Product Change Notification / LIAL-16UCZH910

CCB 4732 Final Notice: Qualification of MMT as an additional assembly site for selected MCP6031, MCP6033, MCP6002, MCP6231 and MCP6241 device families available in 8L DFN (2x3x0.9mm) package.

CCB 4732
Pre and Post Change Summary
PCN#: LIAL-16UCZH910

QUALIFICATION REPORT SUMMARY
RELIABILITY LABORATORY

NSEB

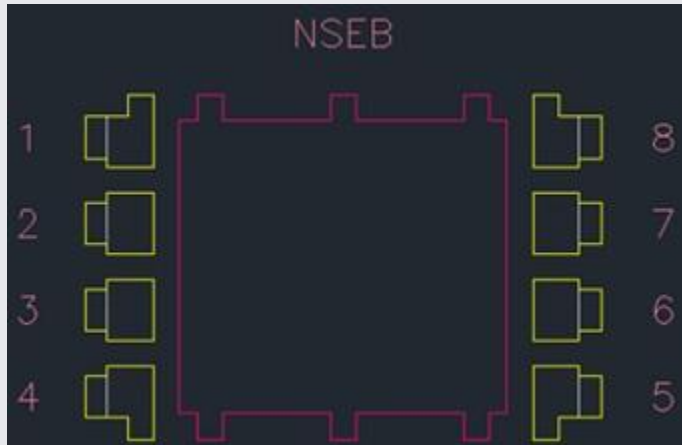
Lead frame material	EFTEC-64T
Lead frame DAP surface prep	Ag
Lead frame lead-lock	No

MMT

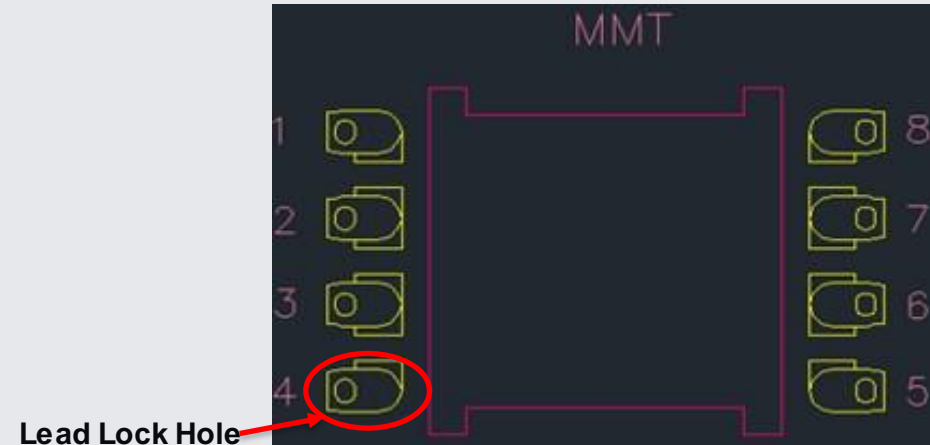
Lead Lock Hole

Lead frame material	C194
Lead frame DAP surface prep	Bare Cu
Lead frame lead-lock	Yes

NOTE: Mold compound material fills the [lead lock hole](#), which provides improved protection against moisture penetration along the edge of the leads (pins) of the package.
